From: [Auluck, Rajender](#)  
 To: [Lee, Brian](#); [Heida, Bruce](#); [Wyman, Stephen](#); [Armstrong, Garry](#); [Roche, Kevin](#); [Scales, Kerby](#); [Parillo, John](#)  
 Subject: FW: Hatch HCVS FIP Follow-Up  
 Date: Monday, January 28, 2019 3:49:18 PM

From: Enfinger, Timothy Lee [mailto:TLENFING@SOUTHERNCO.COM]  
 Sent: Monday, January 28, 2019 2:21 PM  
 To: Auluck, Rajender <Rajender.Auluck@nrc.gov>  
 Subject: [External\_Sender] Hatch HCVS FIP Follow-Up

We have some supplemental information related to the Plant Hatch HCVS FIP for the staff's consideration. Can you provide us a ballpark timeframe for when review may be complete? Here is the supplemental information:

**Action 3: Location of HCVS Batteries and Chargers**

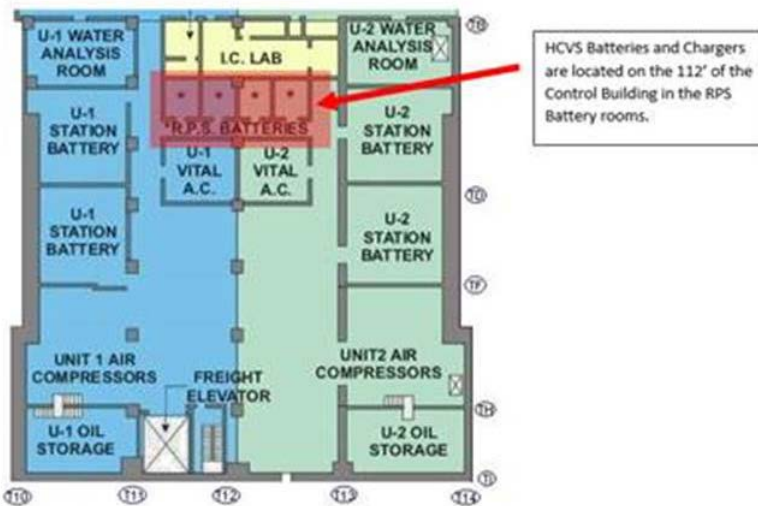
This diagram indicates the location of the HCVS batteries and chargers.
